**Kronospan**

Schedule 5 Response No 3

Figure 5: Annual Mean PM2.5 Impact – Other Sources - % of AQAL

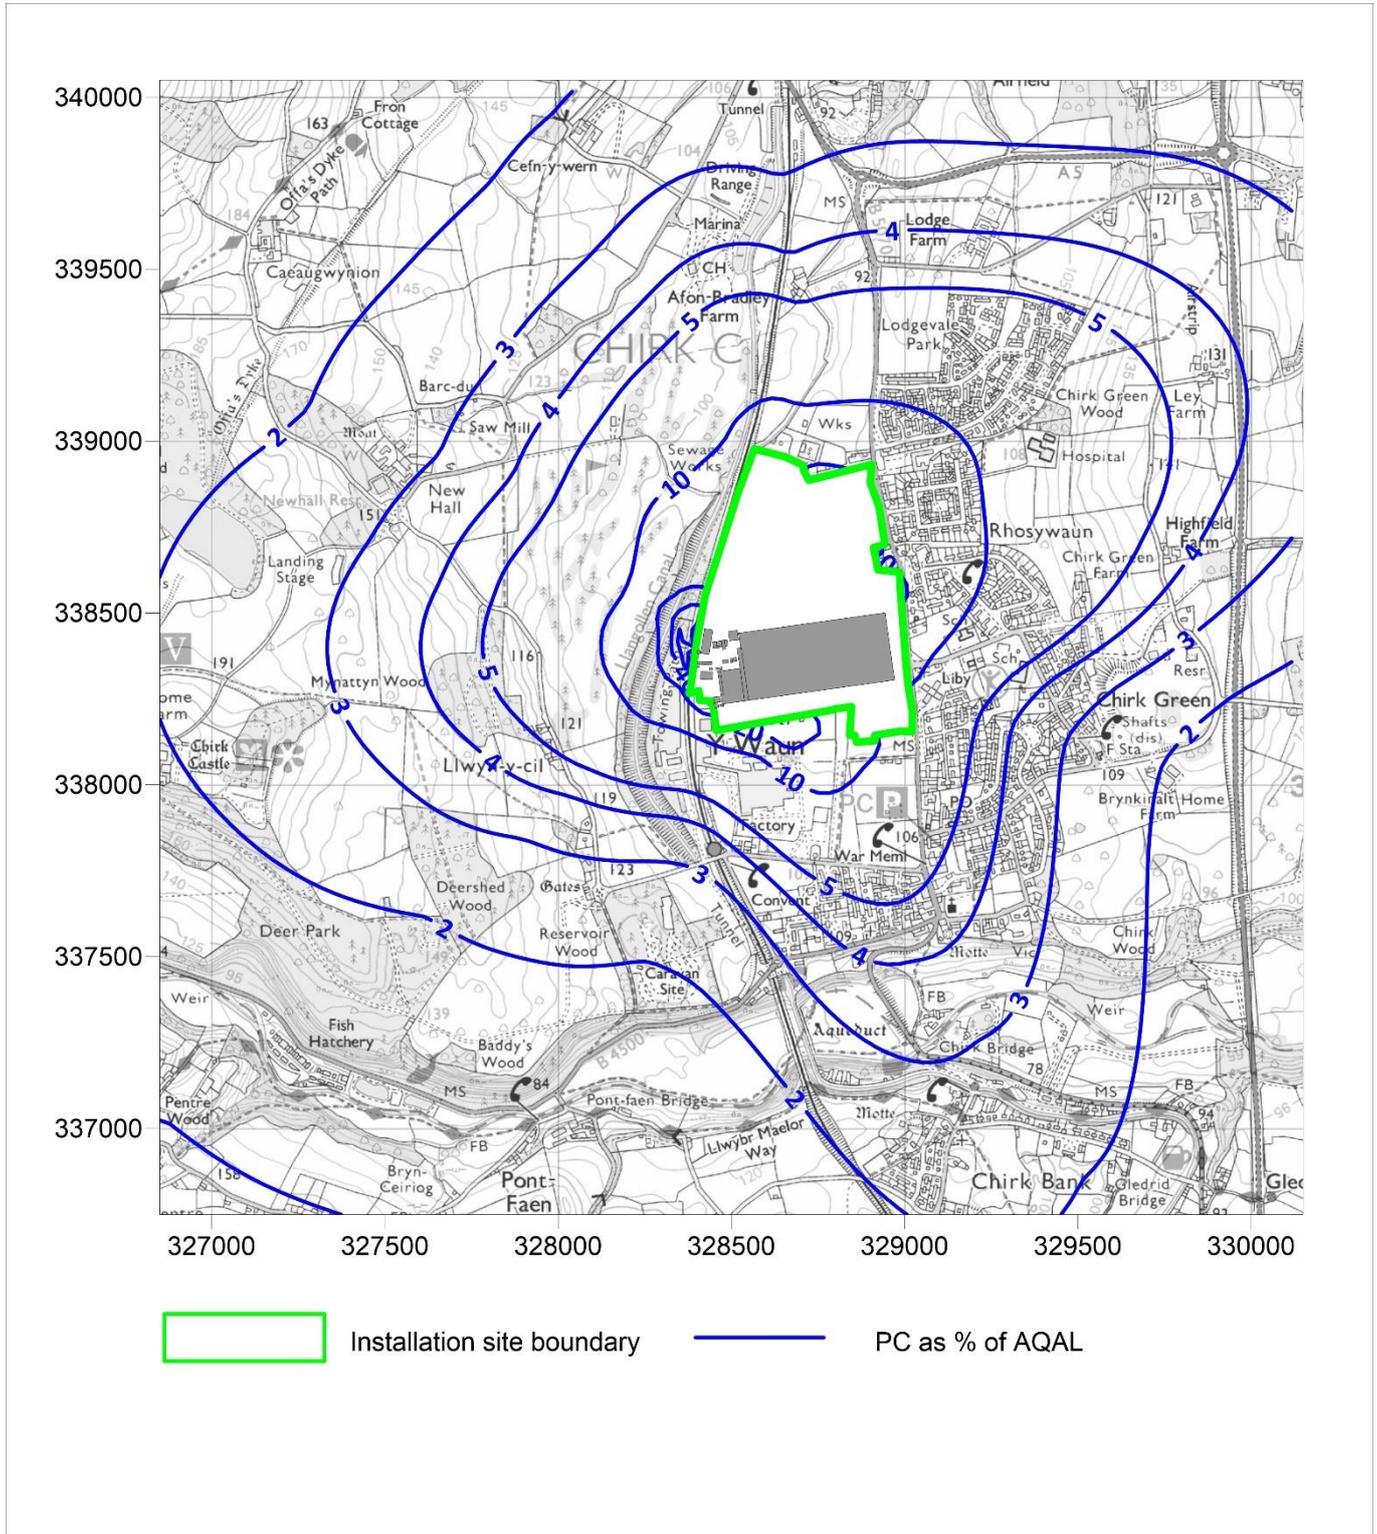
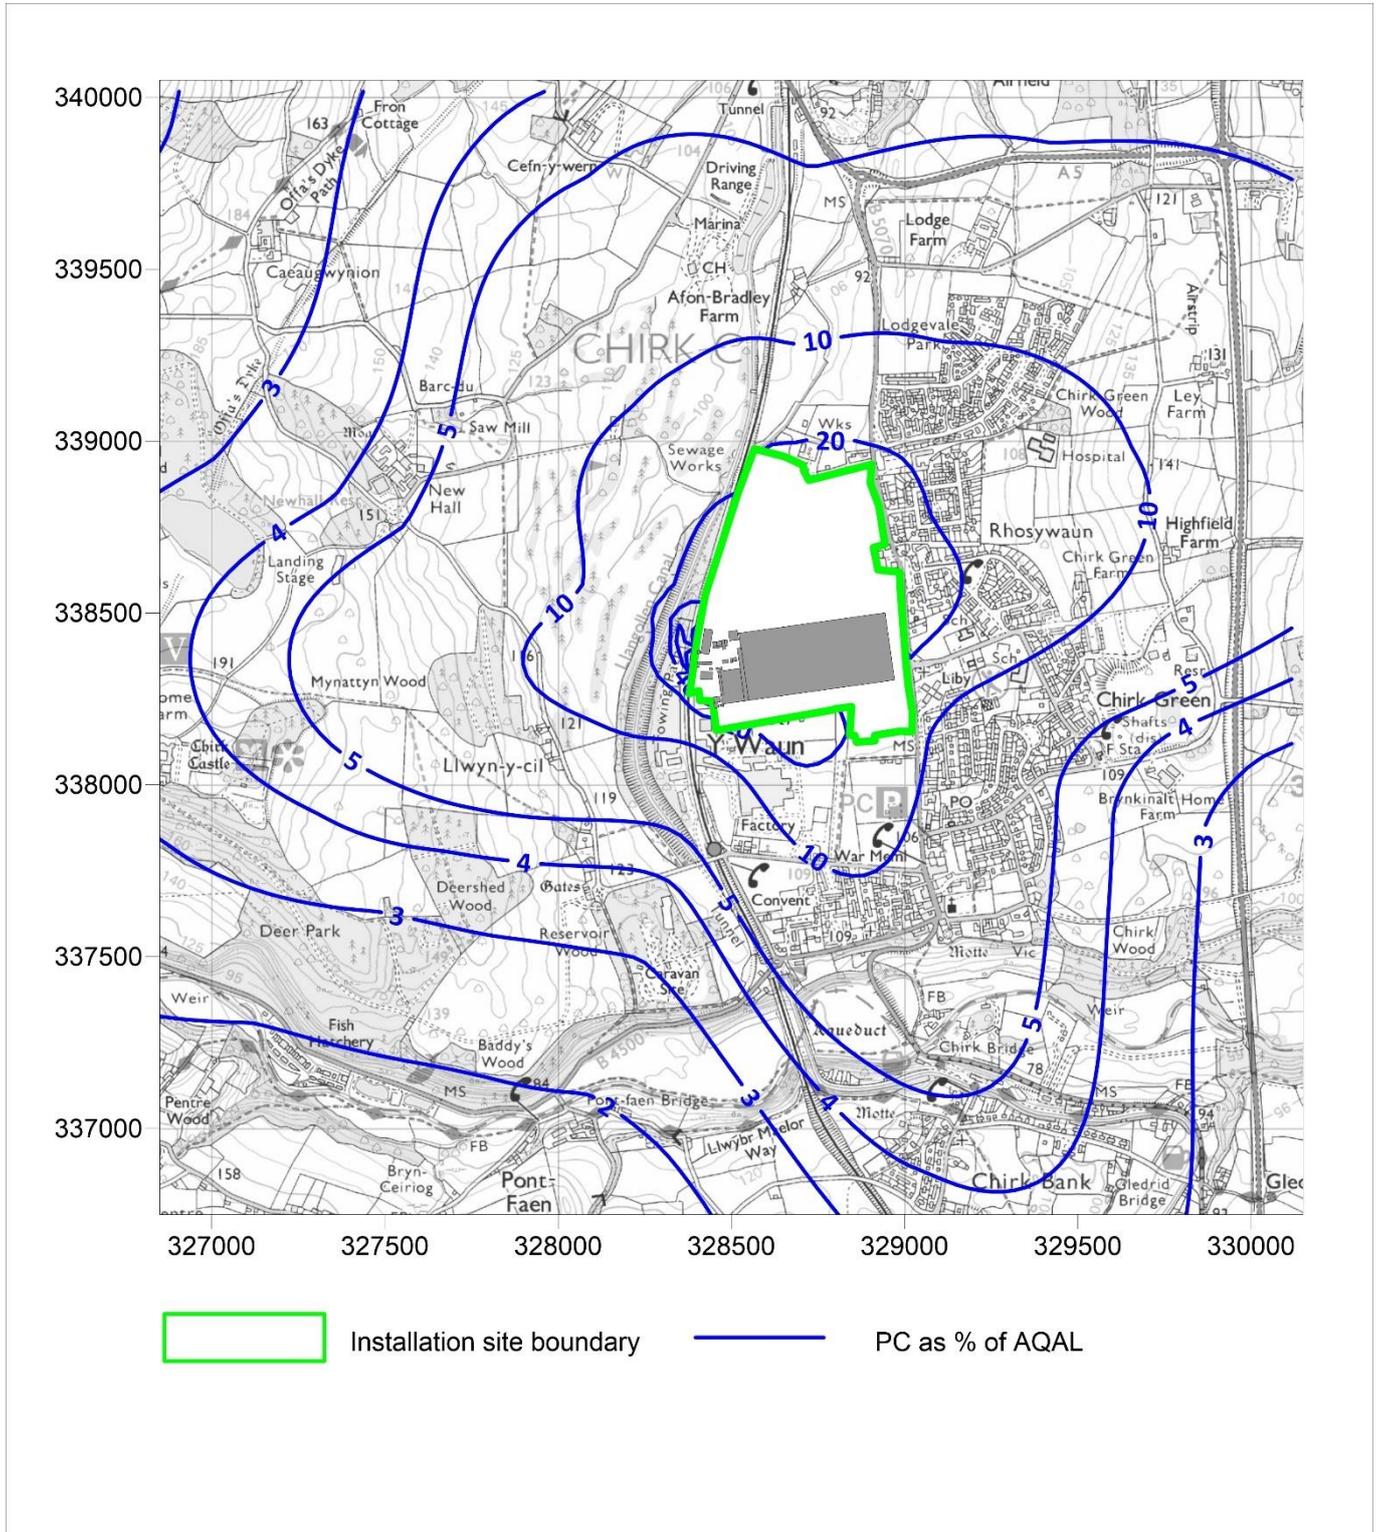
*As such, please confirm the number and location of the bag filter units on site, together with the process areas they serve. Please also update the air quality modelling files and associated assessment report to include releases from these items of plant. More specifically, the modelling for both the Likely and Worst Cases shall be updated to include the predicted impact of long and short-term releases from the bag filter plants. This shall be combined with the process contribution (PC) for other on-site sources of PM to give the overall PC associated with the entire site. This shall*

The dispersion plot files are presented in Appendix A, with the model input table for the additional sources provided in Appendix B. As shown at areas of relevant exposure the predicted impact does not exceed any AQAL. The predicted impacts are based on the following highly conservative assumptions:

Site Plan  
Particulate Filtration Points  
Drawing Number: 7000/604

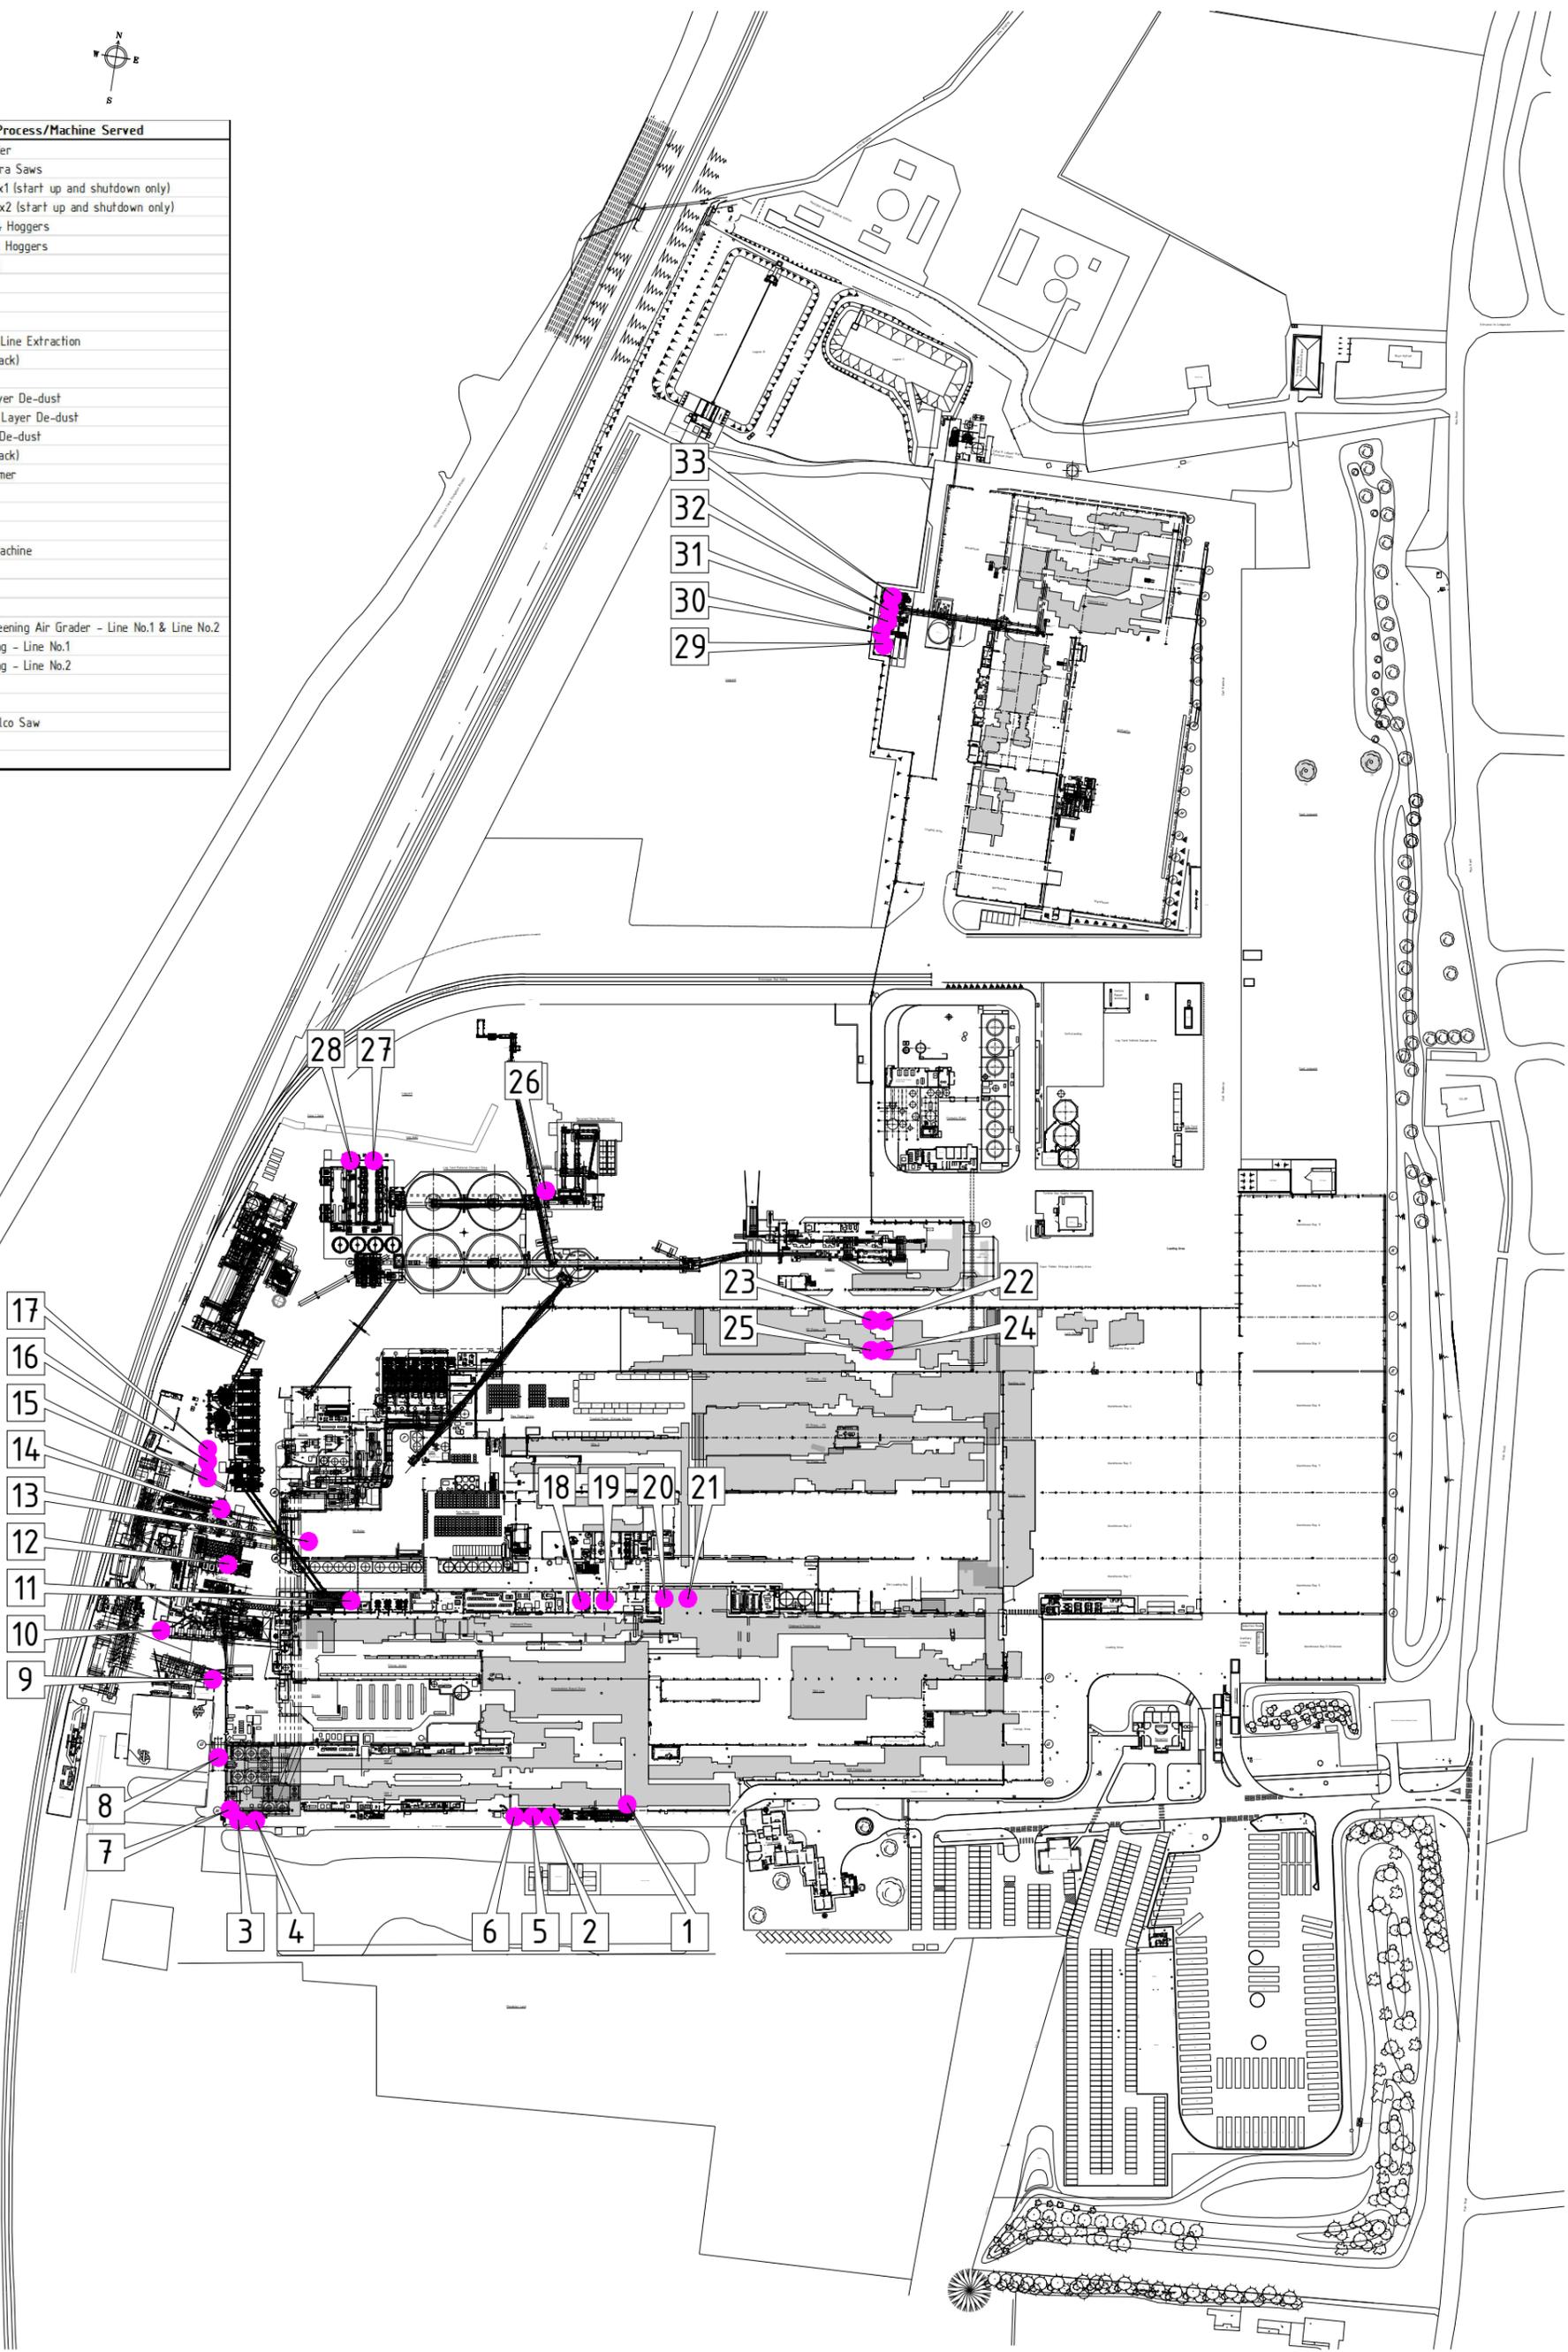
*The Chirk Particleboard Factory installation is equipped with various items of bag filter plant, for abatement of particulate matter (PM) arising inside the process buildings. These plants are subject to Emission Limit Values (ELVs) currently set in Table 6.10.1 of Wrexham County Borough Council Permit WCBC/IPPC/03/KR(V3). However, releases from the bag filter plant are not included as dispersion model inputs in the air quality assessment (Appendix C of variation application EPR/BW9999IG/V008).*

A figure showing the location of each bag filter unit and the process area they serve is provided in Appendix E.
